KINGSTON STEAM PLANT				
PLAN OF BORROW INVESTIGATION				
TENNESSEE VALLEY AUTHORITY MATERIALS ENGINEERING LABORATORY				
SUBMITTED	RECOMMENDED	APPROVED		
KNOXVILLE	10-1775	36	CS	3 6048603A

Kingston Steam Plant - Ash Disposal Area Dikes  
Raising - Soils Investigation Report 11/3/75 and  
Evaluation

KINGSTON STEAM PLANT - ASH DISPOSAL AREA DIKE RAISING - SOIL INVESTIGATION

Kingston Steam Plant - Ash Disposal Area Dike Raising -  
Soils Report 11/3/75 - Evaluation

Kingsport 2 T.F.  
 Ash Dikes  
 Earth Borrow  
 95% S  
 3% wet + 3% dry

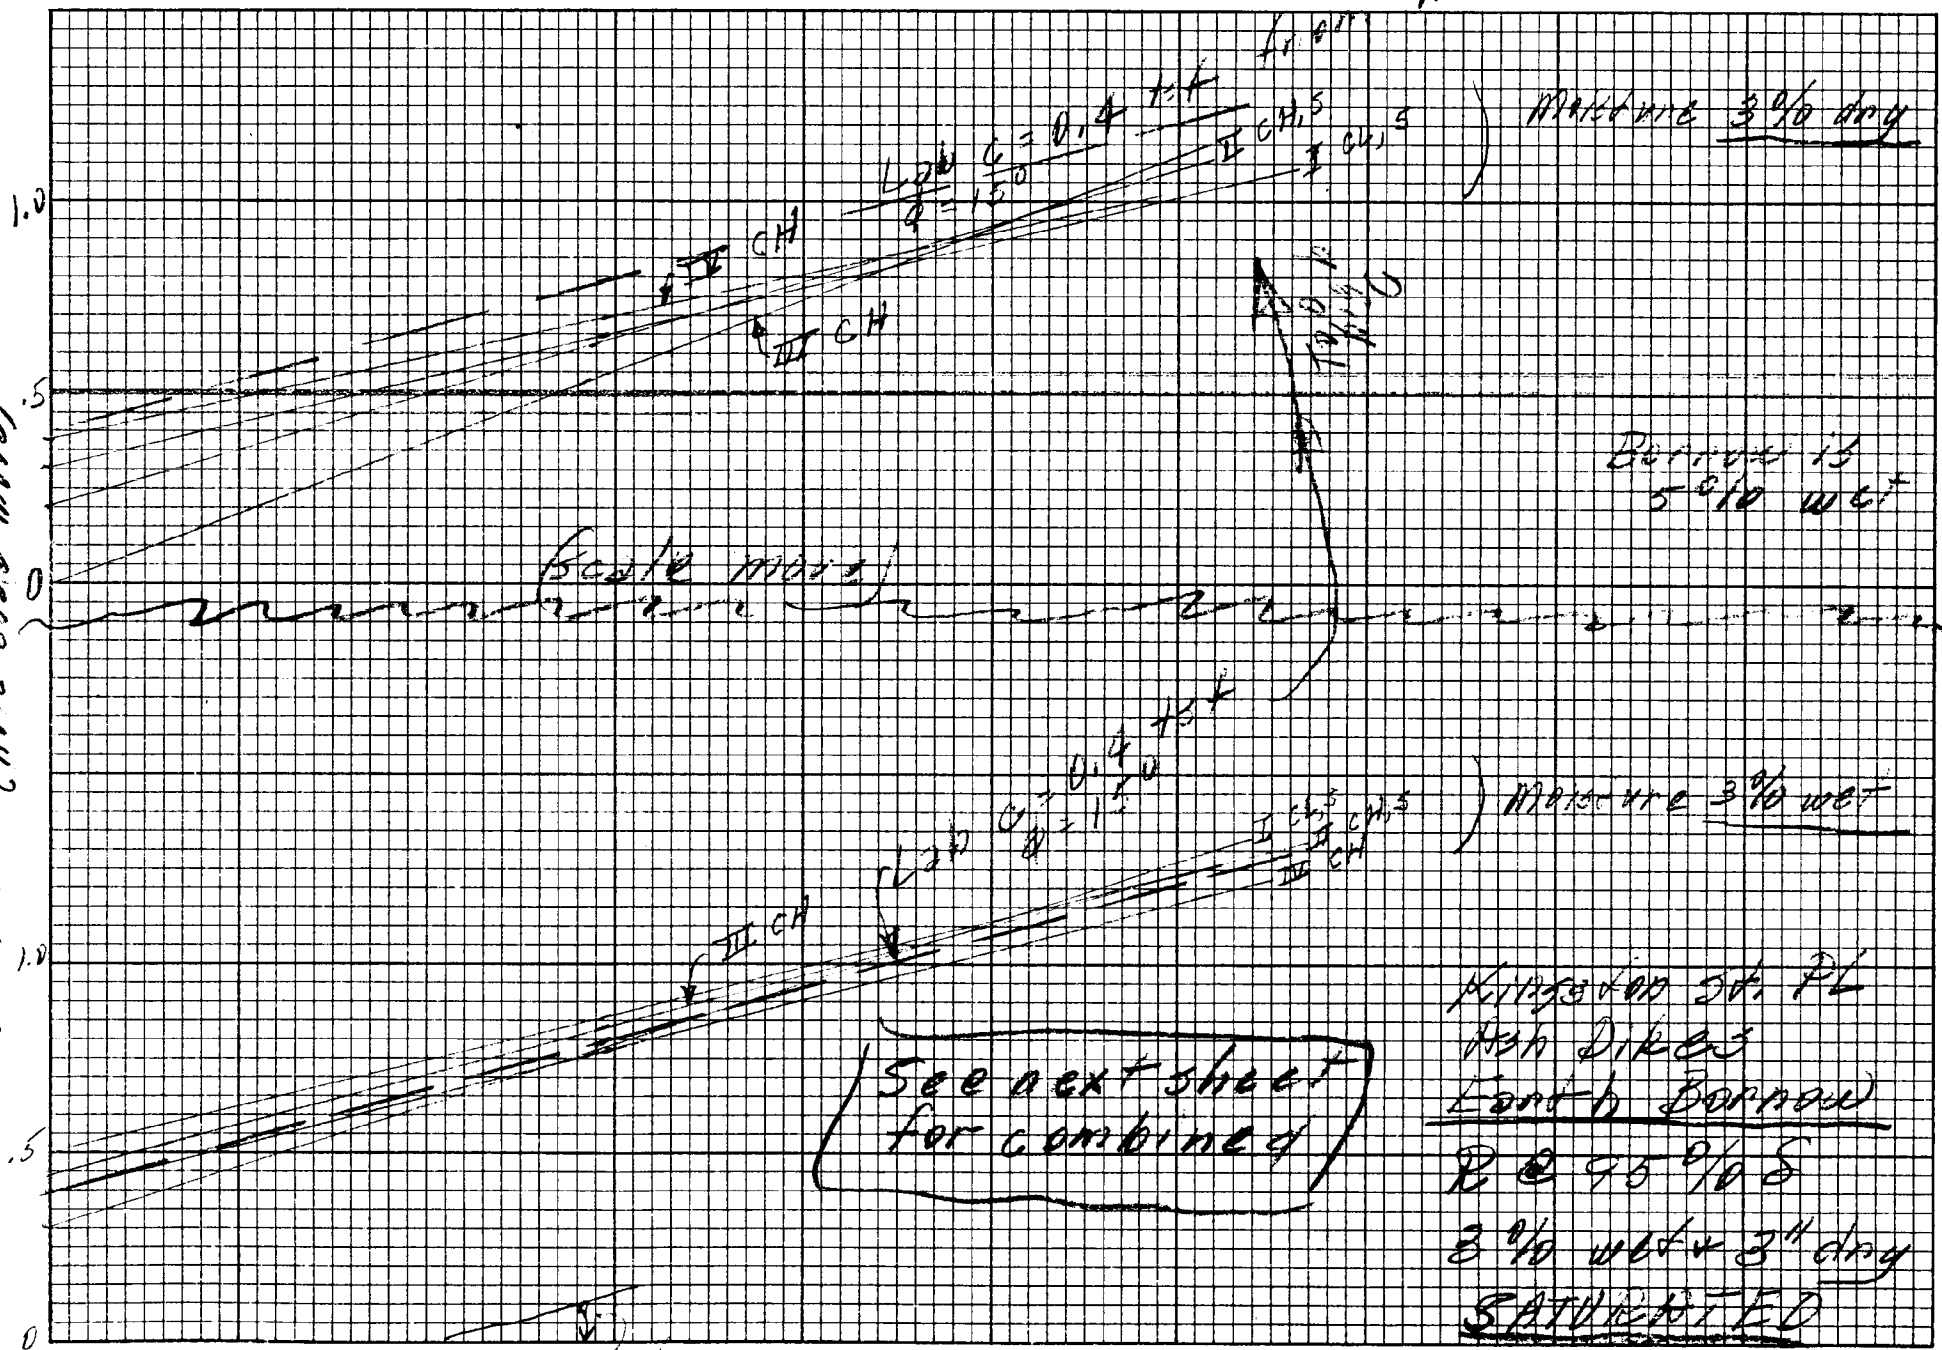
Mixture 3% dry  
 Do not use.  
 strength is too high.

Borrow is  
 5% wet

Mixture 3% wet

L.S. C = 1.0 T.F.  
 $\phi = 6^\circ$  D.K.
